# UNITED STATES PATENT AND TRADEMARK OFFICE

APPLICATION NO.	FILING DATE	FIRST NAMED INVENTOR	ATTORNEY DOCKET NO.	CONFIRMATION NO.
10/799,307	03/12/2004	Jae-Hyun Kim	8054-50 (LW9007US/HJ)	8101
22150	7590	01/13/2006	EXAMINER	
F. CHAU & ASSOCIATES, LLC 130 WOODBURY ROAD WOODBURY, NY 11797			CHIEN, LUCY P	
			ART UNIT	PAPER NUMBER
			2871

## Office Action Summary

## DETAILED ACTION

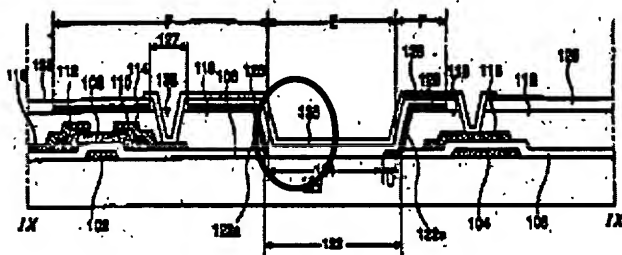
Ha et al discloses in Figure 9D the second edge (circled below) edge removed from the transmitting area thus the distortion from a fringe field can be prevented. And the transmissive area is widened as shown. (Column 12, Row 49-60)

Fig.4

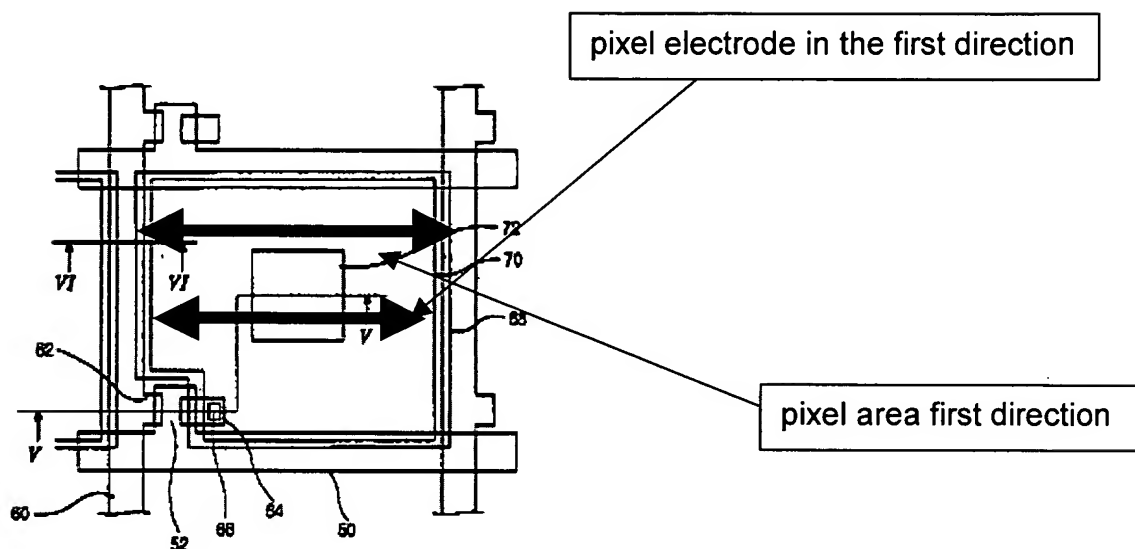
Park et al further discloses in Figure 4 (and figure below) the width of the pixel electrode in the first direction is smaller than the width of the pixel area in the first direction.

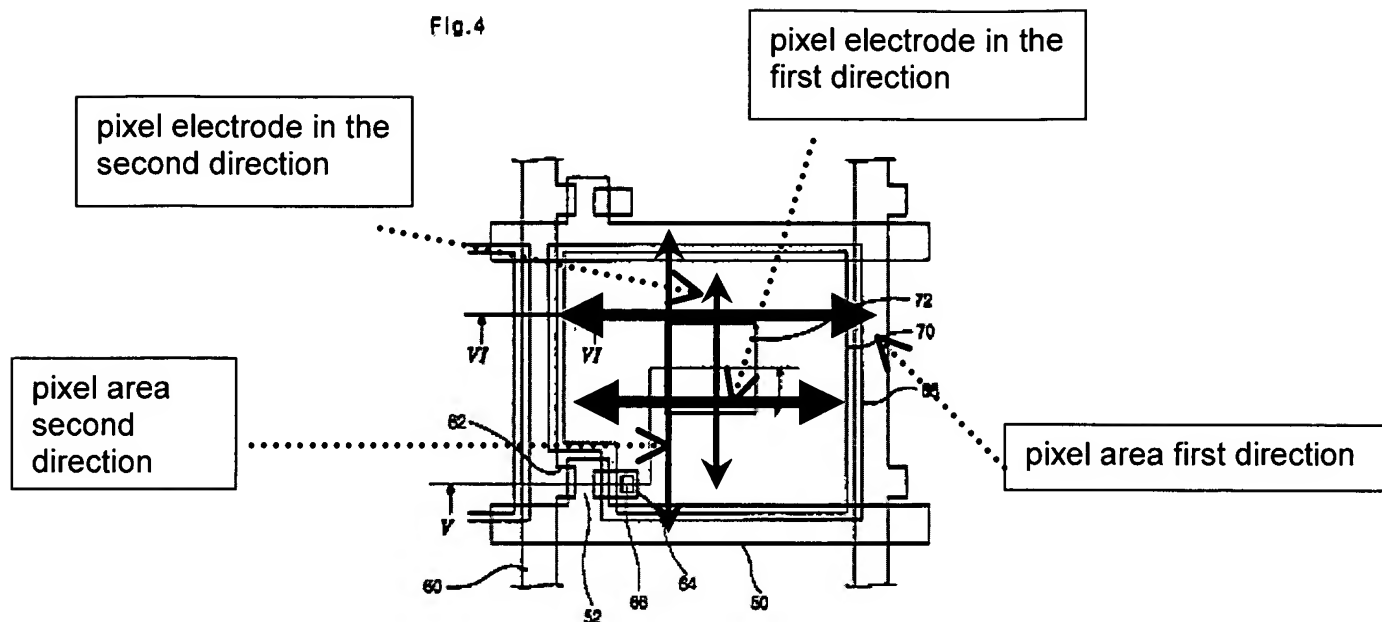
Park et al further discloses in Figure 4 (and figure below) the width of the pixel electrode in the first direction and width of the pixel electrode in the second direction are smaller than a width of the pixel area in the first direction and a width of the pixel area in the second direction.

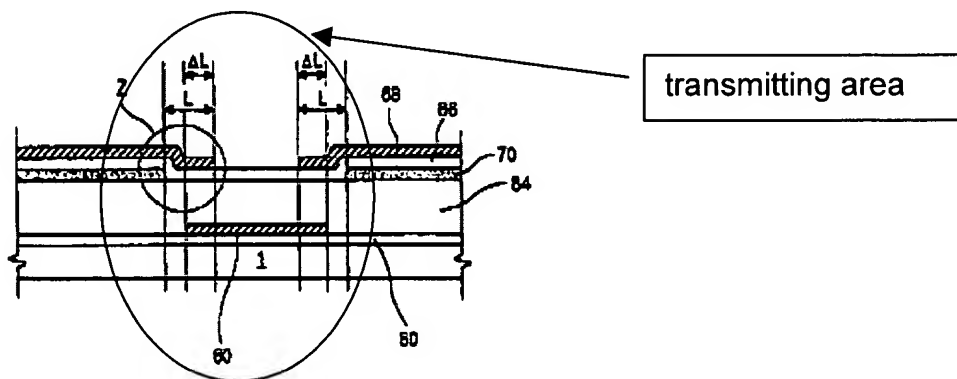
Regarding Argument on page 15 of Remarks sent in 10/28/2005 stating that element (60) is not a transmitting area but a data line. Element (60) is a data line, Examiner was pointing out the area where 60 is located is the transmitting area.
